TVA-82-213A+ PCN Report

AN-60-081

As a result of the introduction of RoHS compliant version and assembly option at an alternate qualified Mini-Circuits facility, the replacement part has been judged by the Mini-Circuits Engineering team as a suitable replacement for the existing TVA-82-213_a.

CASE STYLE

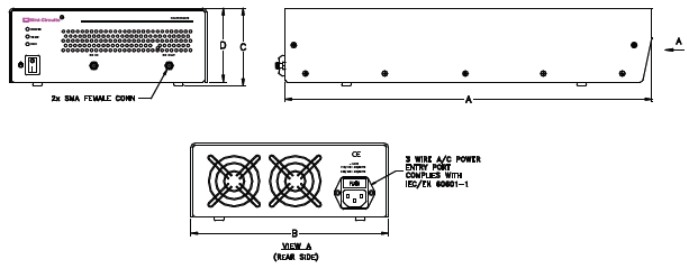
ORIGINAL PART: TVA-82-213	REPLACEMENT PART: TVA-82-213A+																														
<p>CASE STYLE: AP1602</p>  <p>Outline Drawing</p>  <p>Outline Dimensions (inch / mm)</p> <table border="1"> <thead> <tr> <th>A</th> <th>B</th> <th>C</th> <th>D</th> <th>wt</th> </tr> </thead> <tbody> <tr> <td>9.8</td> <td>4.8</td> <td>6.7</td> <td>—</td> <td>grams</td> </tr> <tr> <td>248.9</td> <td>121.9</td> <td>170.2</td> <td>—</td> <td>1700</td> </tr> </tbody> </table>	A	B	C	D	wt	9.8	4.8	6.7	—	grams	248.9	121.9	170.2	—	1700	<p>CASE STYLE: PJ2059</p>  <p>Outline Drawing</p>  <p>Outline Dimensions (inch / mm)</p> <table border="1"> <thead> <tr> <th>A</th> <th>B</th> <th>C</th> <th>D</th> <th>WT.</th> </tr> </thead> <tbody> <tr> <td>15.35</td> <td>8.27</td> <td>3.25</td> <td>3.09</td> <td>GRAM</td> </tr> <tr> <td>389.89</td> <td>210.06</td> <td>82.55</td> <td>78.49</td> <td>2490</td> </tr> </tbody> </table>	A	B	C	D	WT.	15.35	8.27	3.25	3.09	GRAM	389.89	210.06	82.55	78.49	2490

- 1) FIT and FORM change for RoHS version
- 2) FUNCTIONAL changes as follows:

COMPARISON PERFORMANCE CURVES^a: $T_{AMB}=25^{\circ}C$

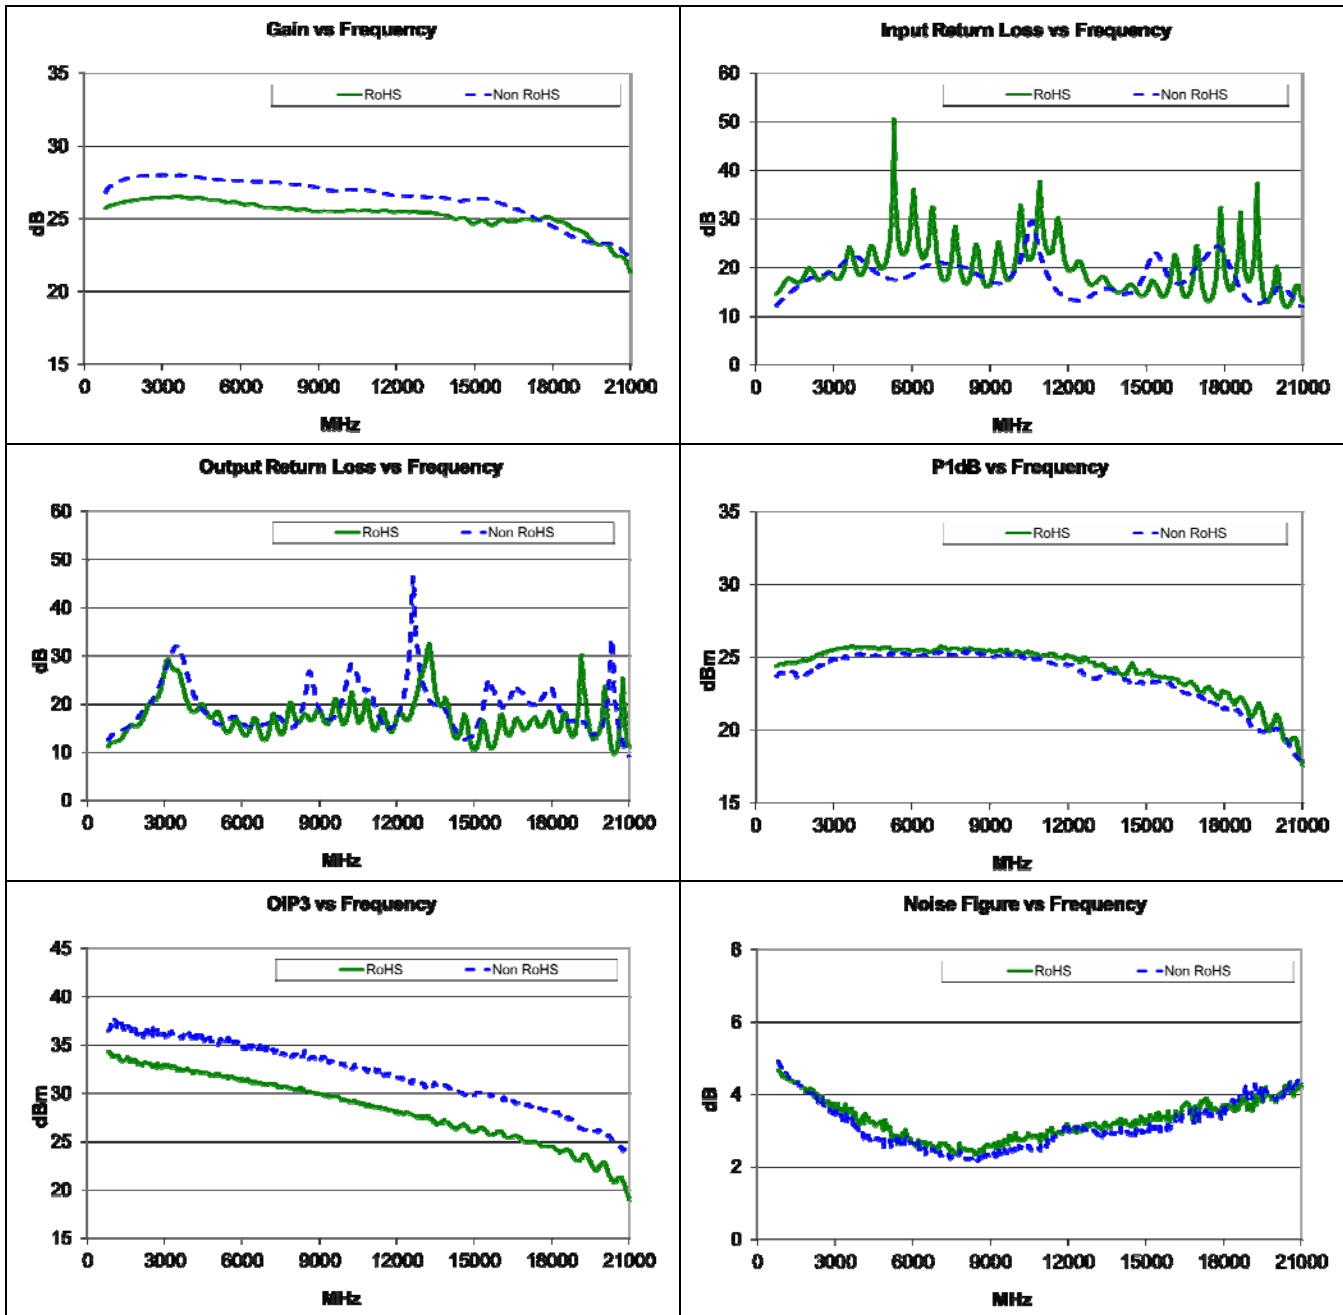
3) TYPICAL PERFORMANCE COMPARISON_a: T_{AMB}=25°C

Parameter	Freq (MHz)	Non RoHS (TVA-82-213)		RoHS (TVA-82-213A+)	
		Data of 1 unit		Data of 2 units	
		Min	Max	Min	Max
Gain (dB)	800-21000	22.13	28	19.91	26.88
Gain Flatness (dB)	800-21000	-----	+/-2.93	-----	+/-3.49
Input VSWR (:1)	800-21000	-----	1.68	-----	1.82
Output VSWR (:1)	800-21000	-----	2.07	-----	2.07
P1dB (dBm)	800-21000	17.94	-----	15.50	-----
OIP3 (dBm)	800-21000	23.75	-----	17.73	-----
Noise Figure (dB)	800-21000	-----	4.93	-----	4.85
AC Supply (V)	-----	-----	110/220	-----	110/220
